Product Change Notification: BLAS-25KBJP585

CCB 7955 Final Notice: Qualification of MTAI as an additional final test site for MIC4420YM, MIC4420YM-TR, MIC4420ZM and MIC4420ZM-TR catalog part numbers (CPN) available in 8L SOIC (.150in) package.

CCB 7955
Pre and Post Change Summary
PCN #: BLAS-25KBJP585

QUALIFICATION REPORT SUMMARY

STAR

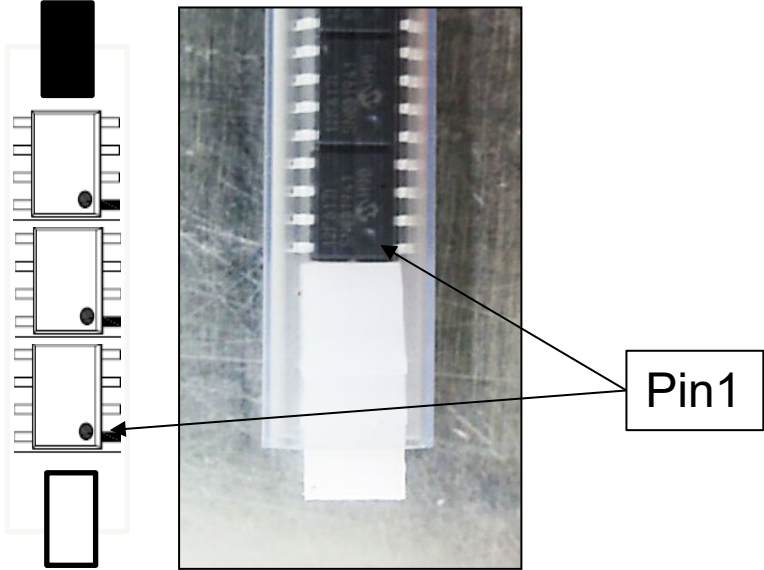
Media	Pin1 Side Color	Opposite Side Color
Plug	Grey	Grey

MTAI

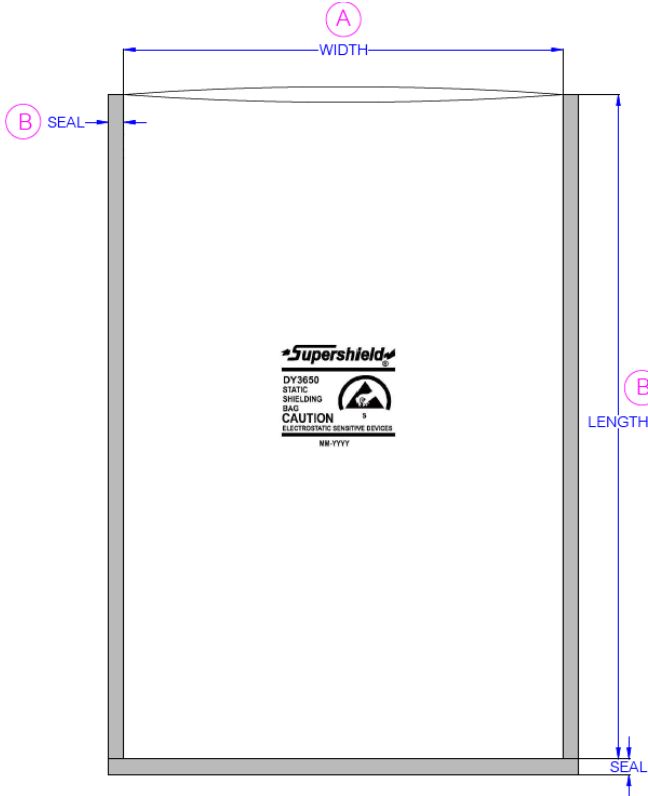
Media	Pin1 Side Color	Opposite Side Color
Plug	WHITE	BLACK

Plastic Reel – Tape and Reel

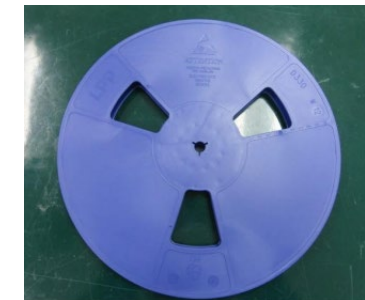
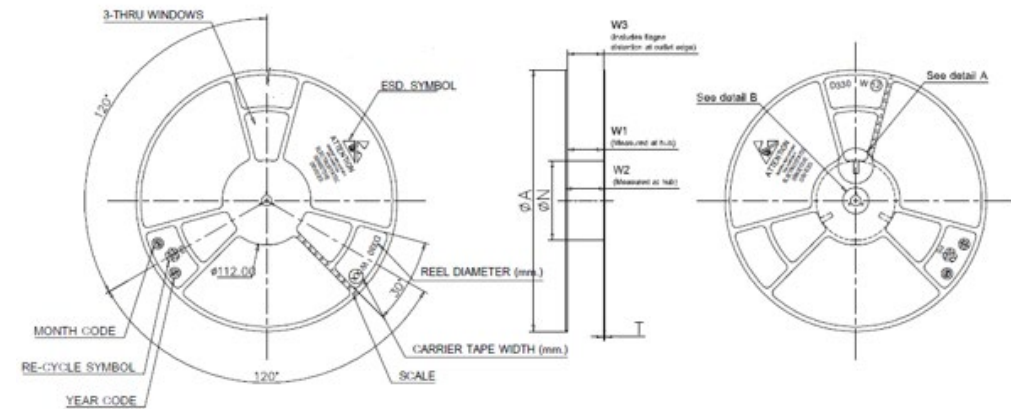
Plant	Reel Diameter (mm)	Reel Hub Size (mm)	Reel Width Max (mm)	Color
STAR	330±2.0	100±2.0	18.40	Blue
MTAI	330 ±2.0	100 ±2.0	18.40	Dark Blue
